**COMMONWEALTH OF KENTUCKY
BEFORE THE PUBLIC SERVICE COMMISSION**

ELECTRONIC 2020 INTEGRATED)	CASE NO.
RESOURCE PLAN OF BIG RIVERS)	2020-00299
ELECTRIC CORPORATION)

**SIERRA CLUB’S INITIAL COMMENTS
ON BIG RIVERS’ 2020 INTEGRATED RESOURCE PLAN**

Sierra Club Technical Comments in PSC Case No. 2021-00079: Clean Energy Portfolio Cost-Effectively Replacing R D Green Coal Units by 2023, Avoiding CCR Compliance Costs

Figure 1: Cost comparison of building and operating a new clean energy portfolio vs. cost of conversion and operation of coal-fired Green

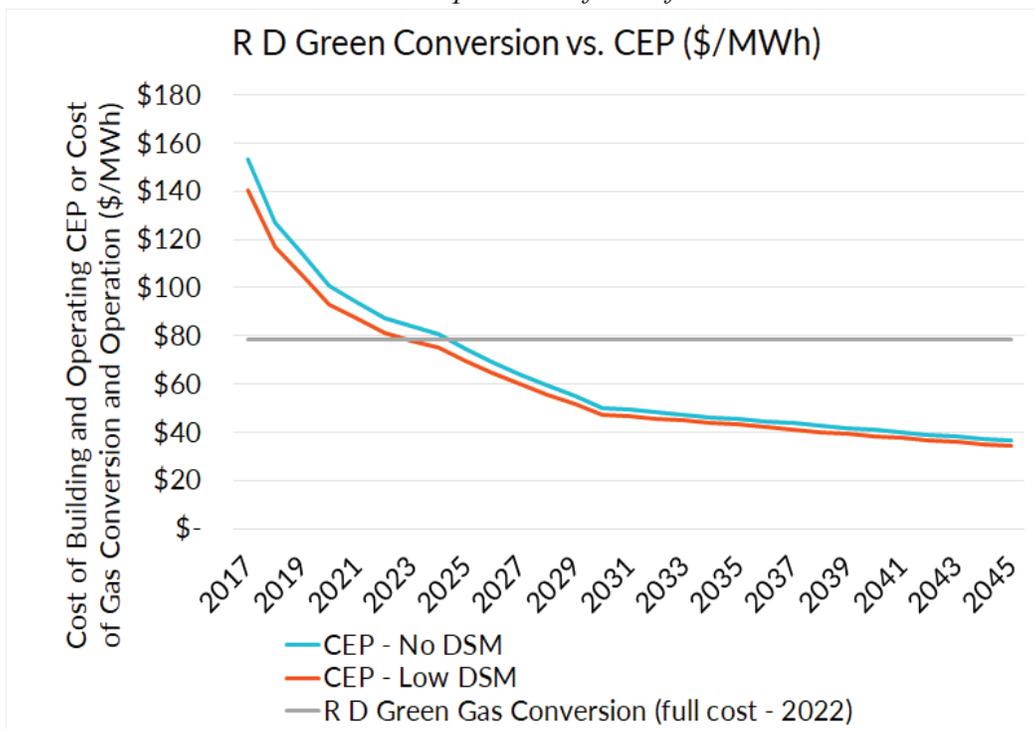
The results of the CEP model are shown below in Figure 1 (cost comparison with converted coal plant) and Table 1 (technology mix of the clean energy portfolio). The levelized cost of energy (LCOE) of the CEP would be lower than the cost of the gas conversion in 2023, only one year after the proposed conversion. More details on our methodology and data sources are discussed in the Sources and Methodology section below.

Our analysis shows that a clean energy portfolio could cost-effectively replace all units of Green by 2023, only one year after Green retires and before the “optimal plan” in the IRP expects the new gas plant online. Using clean energy rather than converting to gas would save customers over \$95.7 million dollars over the lifetime of the resource. This is based on the net present value of the gas conversion or clean energy portfolio over a 20 year operating lifetime.

This result means that Big Rivers should not be considering conversion of the Green coal plant to burn gas and instead should plan for replacement with clean energy sources. In Big Rivers’ “optimal plan” in the IRP, they planned to retire Green in 2022 and not receive energy from a newly built gas plant until 2024.
